REPORT TO:	Planning Committee
REPORT NO.	HCWD/43/12
DATE:	30 July 2012
REPORTING OFFICER:	Head of Community Wellbeing & Development
CONTACT OFFICER:	Simon Greenland (Ext. 8781)
SUBJECT:	Application p/2009/0330 132 kv single circuit flat formation overhead line reinforcement between Legacy substation, Wrexham and Oswestry substation (also within Esclusham, Chirk & Erbistock communities)
WARDS:	Esclusham, Ponciau, Ruabon, Marchwiell, Penycae and Ruabon south, Chirk north, Chirk south

To advise Members of the progress of the application and amendments, and to seek clarification of the Local Planning Authority's views to be put to the Secretary of State for Energy and Climate Change.

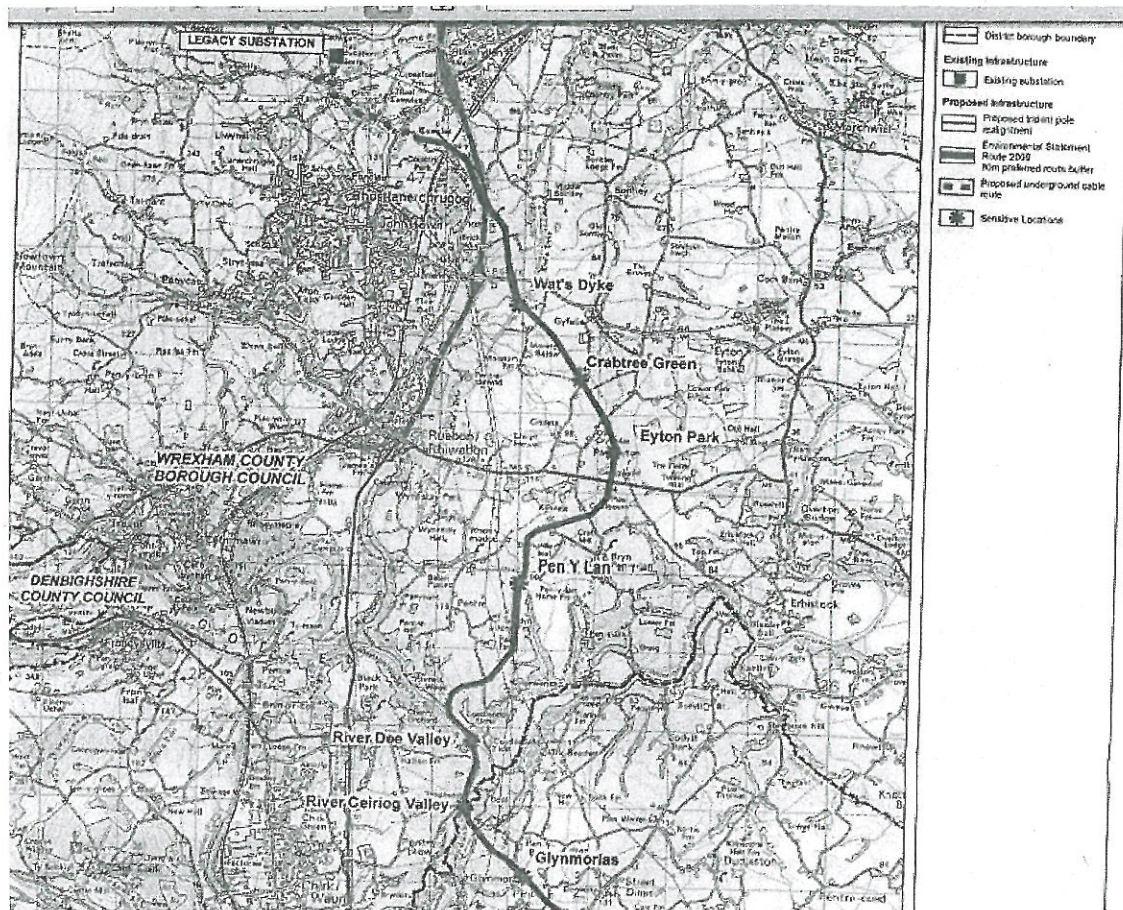
- 13 On 9/7/2012 revised details of the proposals were received, as follows:
1. A revised design of the wooden poles, involving a single pole Trident design, rather than the double pole design. The height of the poles varies but is typically reduced from a maximum of 15 metres to 14 metres, and the maximum width from 6 metres to 5 metres.
